## **PLANNING COMMISSION MEETING AGENDA REGULAR MEETING**

**October 22, 2024**

SUBJECT: PUBLIC HEARING – SPECIAL USE APPROVAL AND PRELIMINARY SITE PLAN REVIEW (SU JPLN2024-0021) – Proposed Residence Inn Hotel, South side of Butterfield, East of Coolidge (2125 & 2155 Butterfield), Section 29, Currently zoned BB (Big Beaver) Zoning District.

## Special Use and Preliminary Site Plan For City of Troy, Michigan

**LANDSCAPE PLAN**

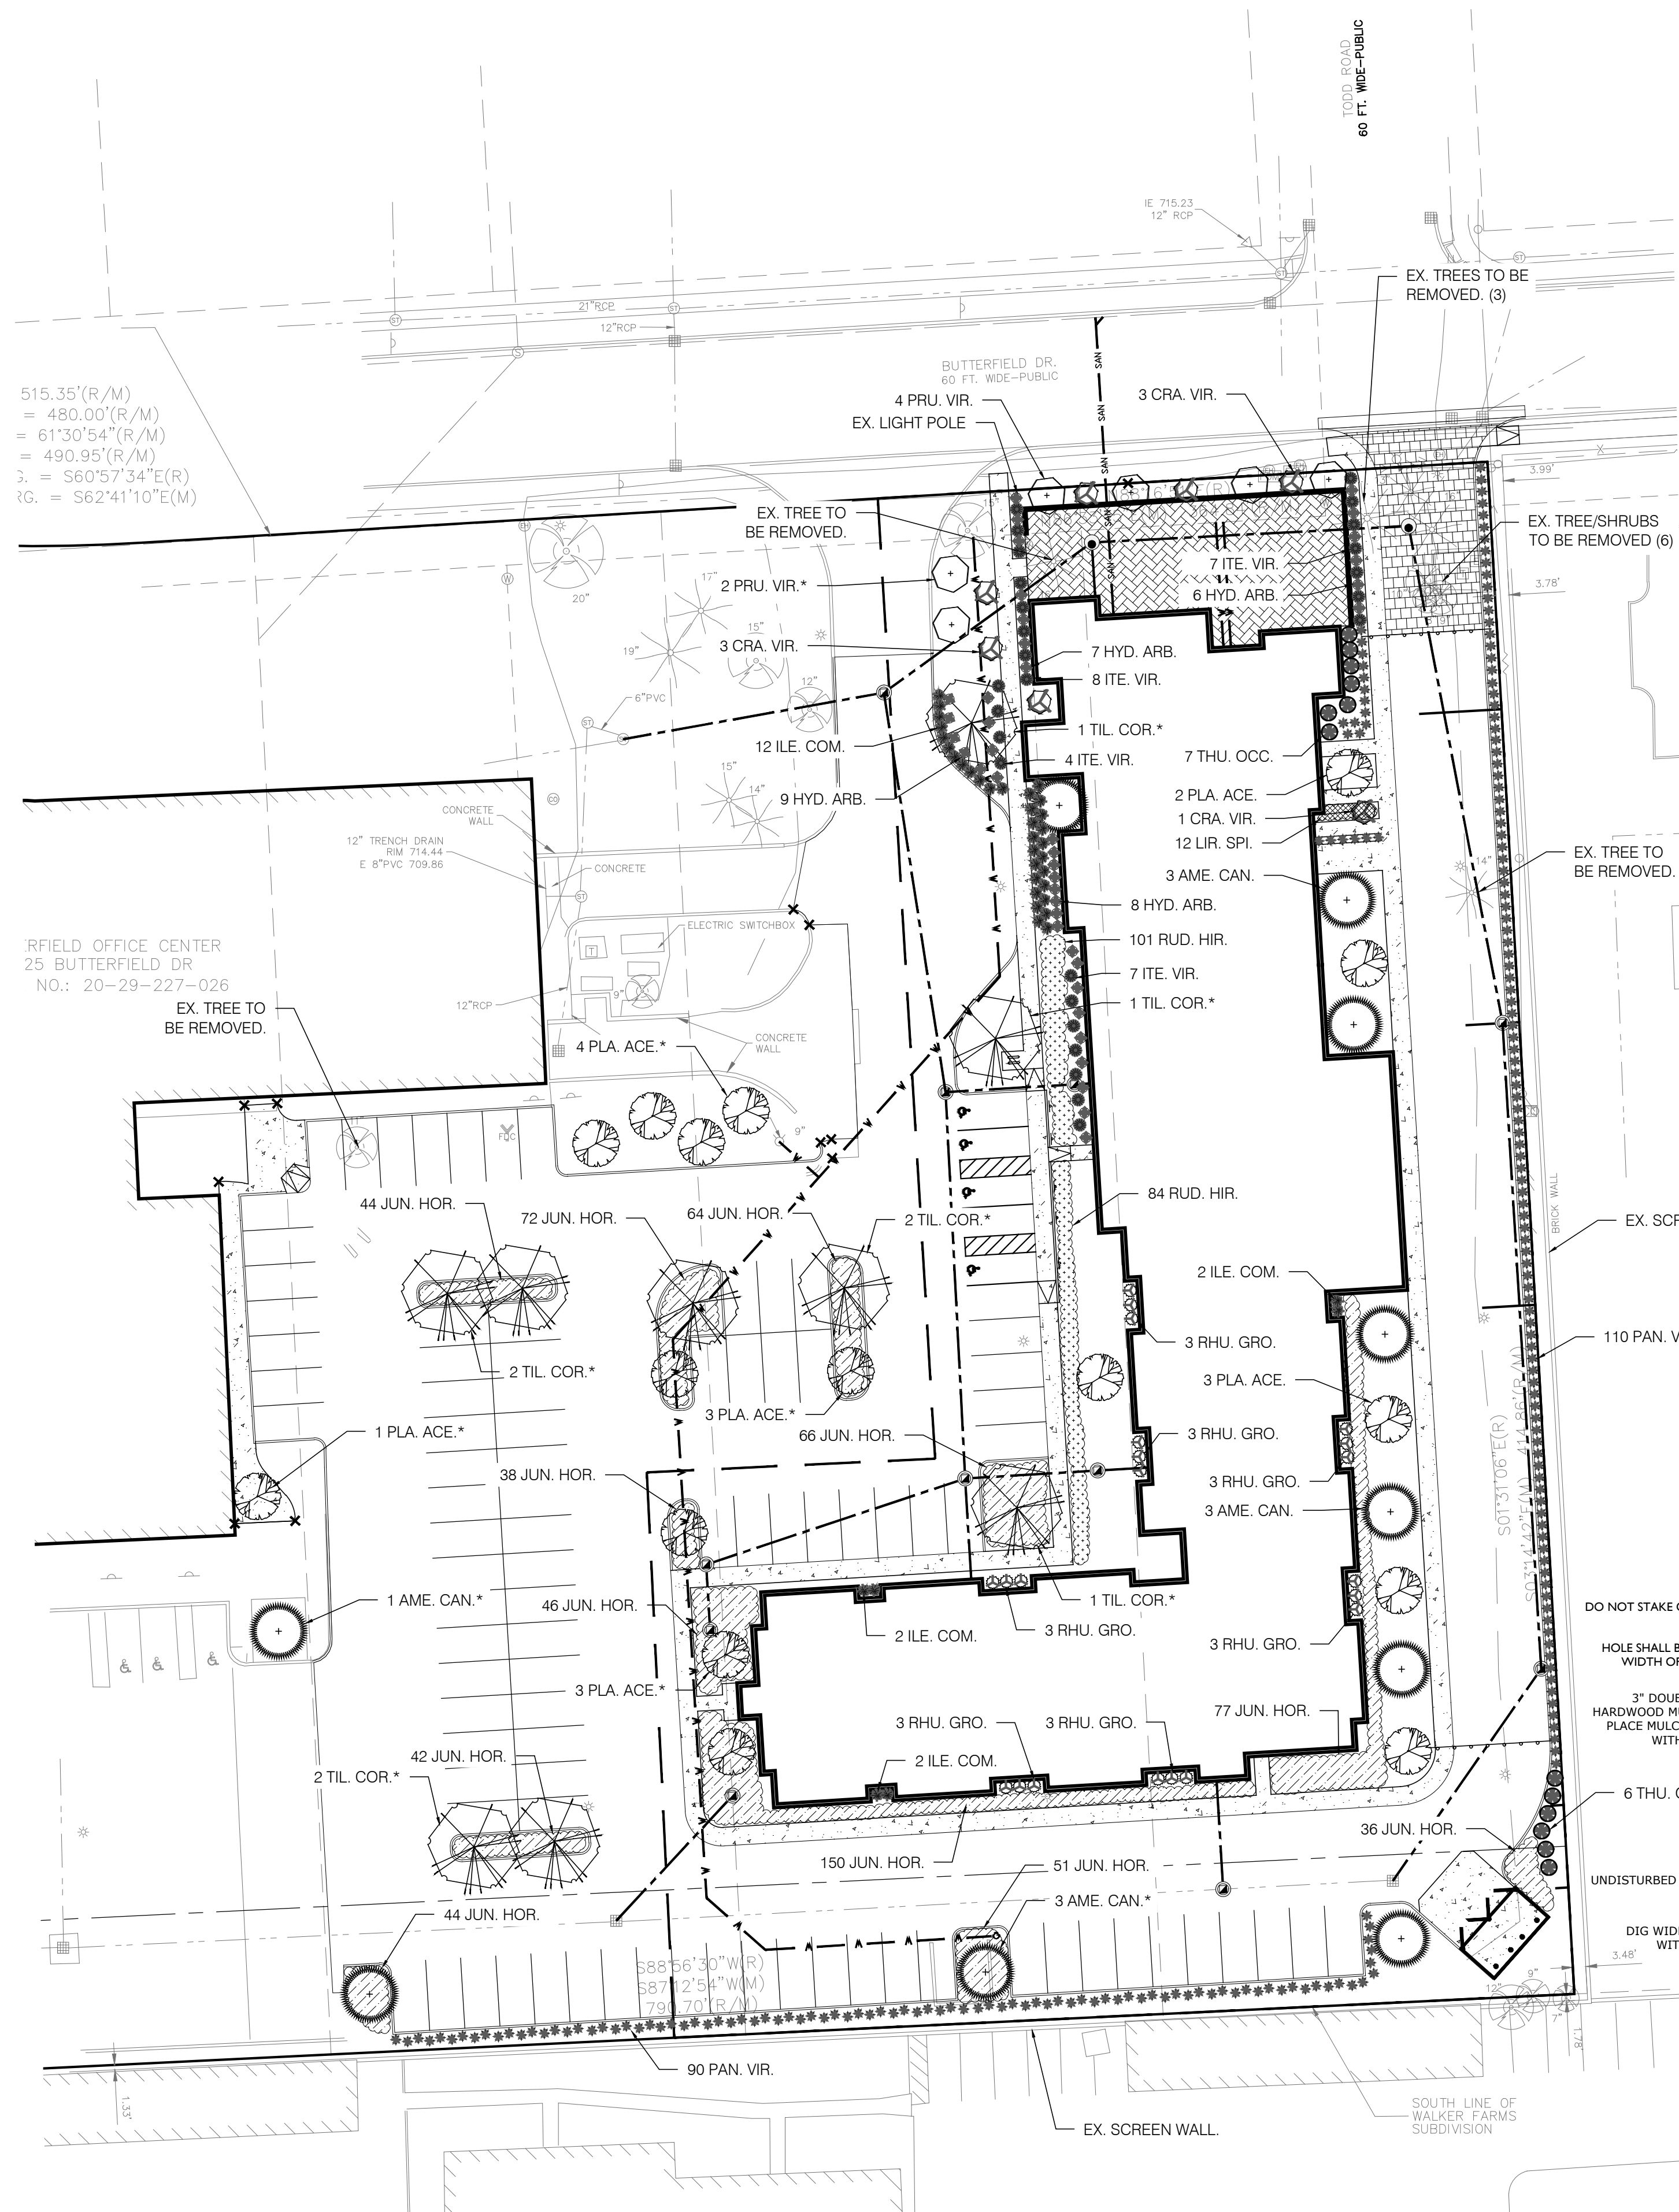
A landscape plan has been provided on Sheet C3.2. The following table discusses the development's compliance with the landscape requirements set forth in Section 13.02.

Section 13.02 requires all landscape plans to be prepared and stamped by a licensed landscape architect. In a memo dated September 11, 2024, the applicant stated that a stamped landscape plan will be provided “at a later date.” We emphasize that the professional seal of a landscape architect is a required component of a site plan application and preliminary site plan approval.

***Items to be Addressed:*** 1). *Landscape plan and tree inventory shall be stamped by a licensed Landscape Architect.*
